**Subject:** 14 Ernest Street Balgowlah Heights NSW 2093 DA 2020/1173 WRITTEN  
SUBMISSION: LETTER OF OBJECTION Submission: Christie

SUBMISSION: CHRISTIE  
a written submission by way of objection to DA 2020/1173

Re:  
14 Ernest Street Balgowlah Heights NSW 2093  
DA 2020/1173

*The proposed development includes alterations to the ground floor, a new first floor, pool and associated landscaping works.*

### **3.4.1 Sunlight Access & Overshadowing**

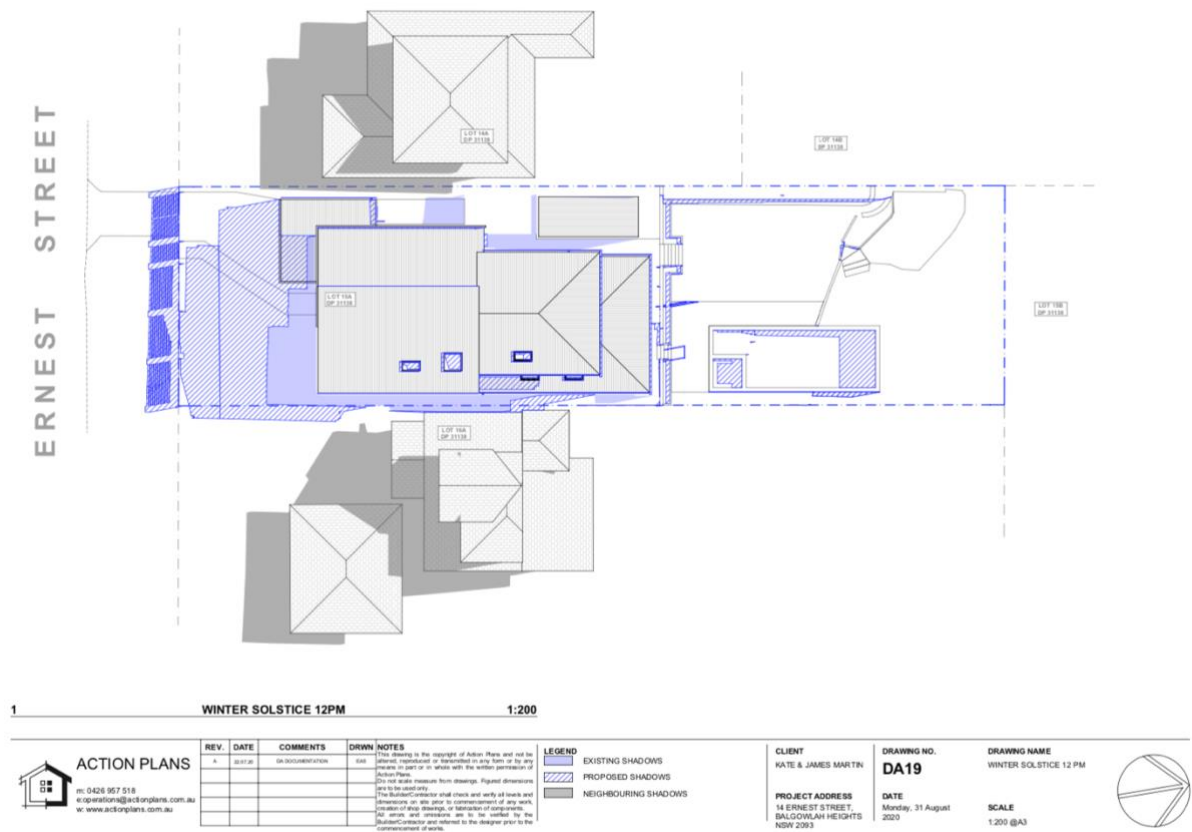
We contend that the proposed development does not accord with this clause due to the multiple non-compliances to development standards, that cause direct amenity harm to our property.

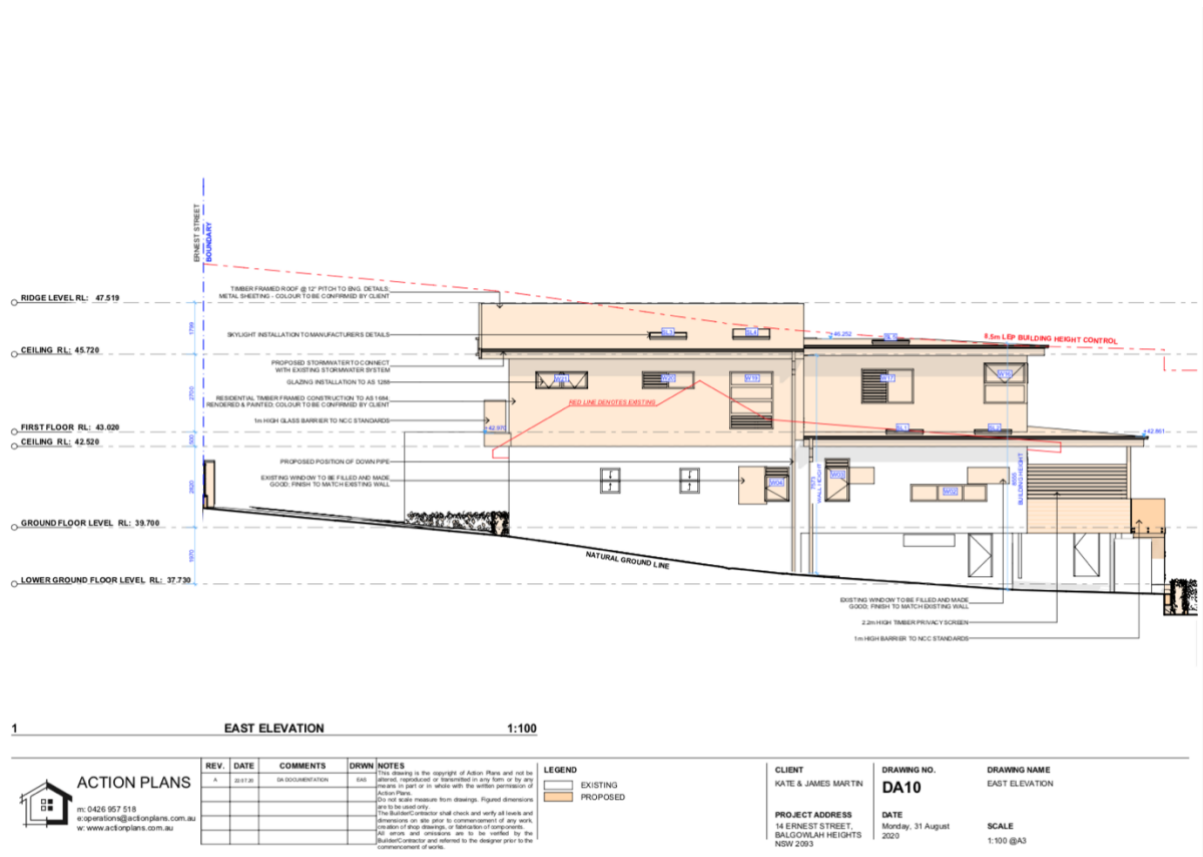
We contend that the proposed development does not accord with this control.

We ask for a compliant side setback of 2.75m facing our property at the first floor. This outcome will allow greater privacy outcome from the proposed first floor windows by the increase of distance. We ask for all windows facing the side setback zone to have 1.6m high sills.

The proposed non-compliant side setback facing our property

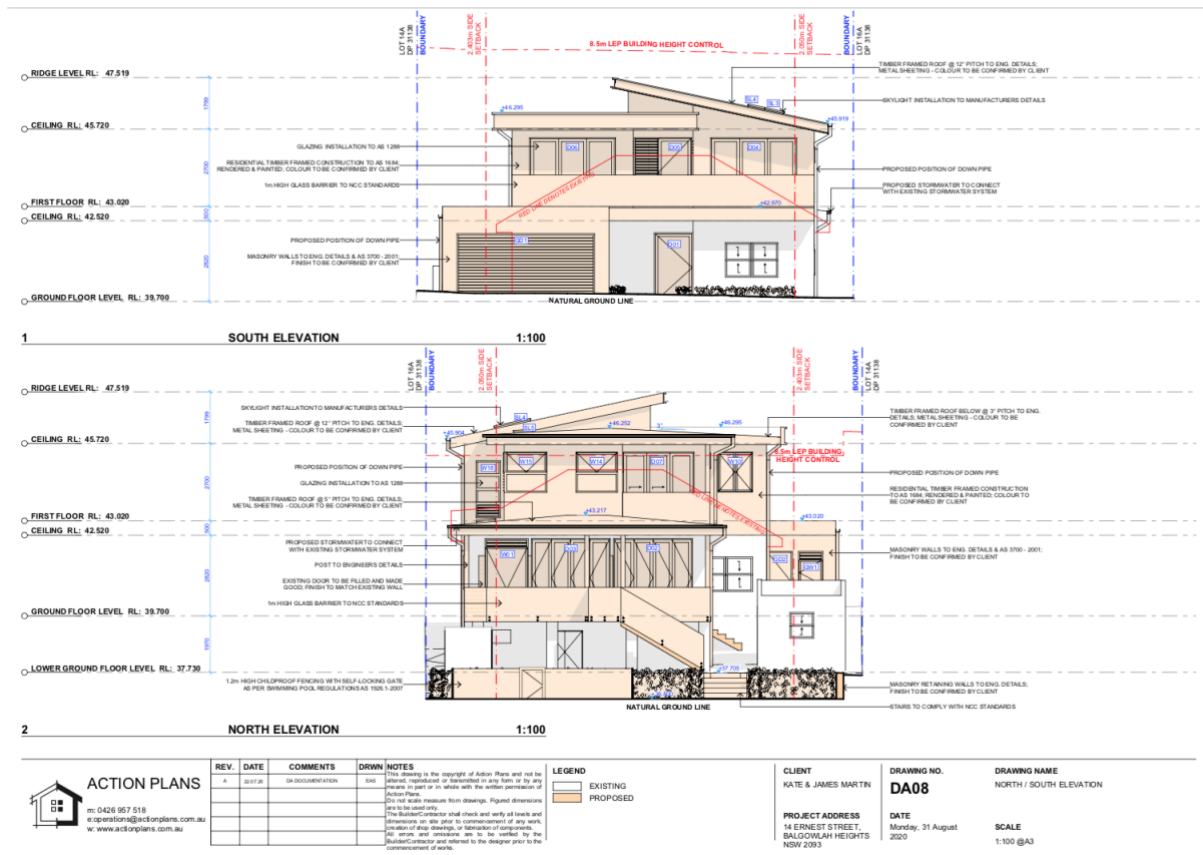
We require a full 1/3 wall height side setback at the first floor to 2.75m.

- A negative presentation to the streetscape
- Privacy, solar access, is not retained for neighbours
- Streetscape character is not maintained and improved

#### **4.1.19 Swimming Pools, Spas and Water Features**

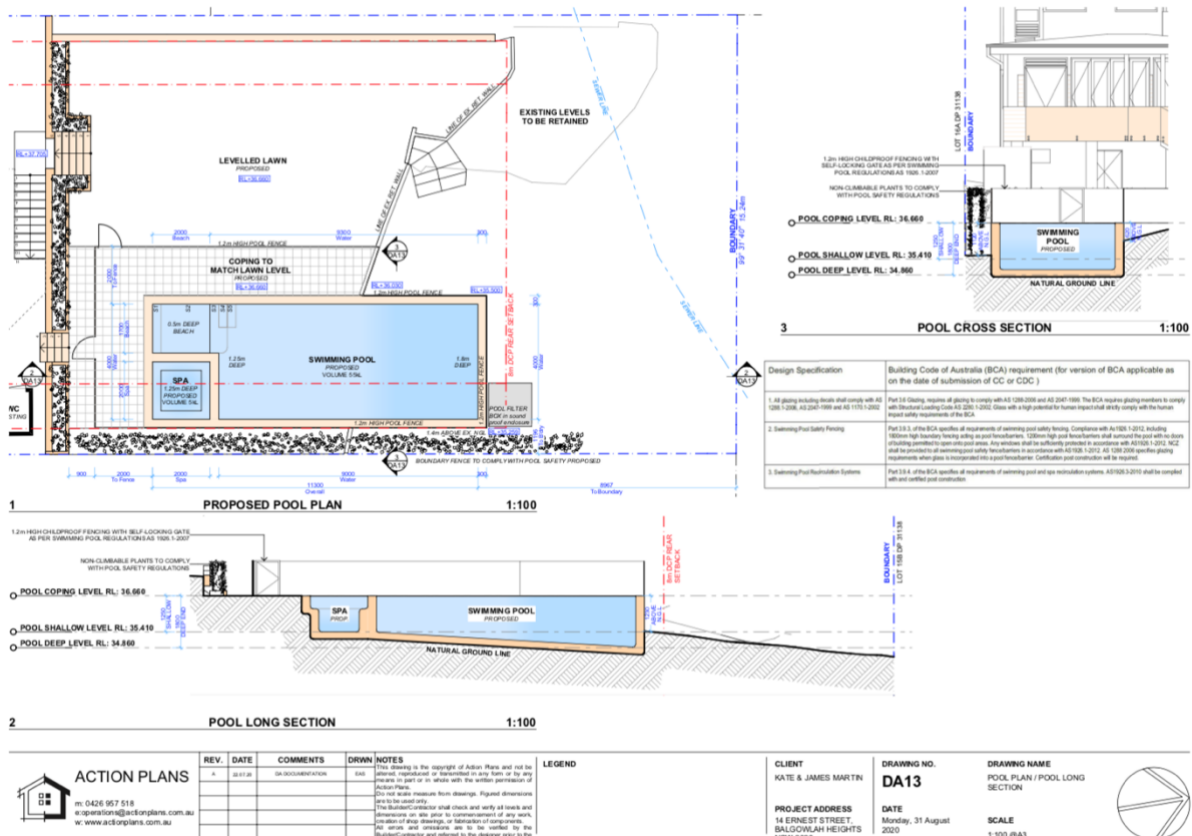
The proposed swimming pool is inappropriate in regards to character and amenity of the neighbourhood.

It has setbacks to the side boundary is inappropriate, as if forces a pool fence to be constructed on the boundary.
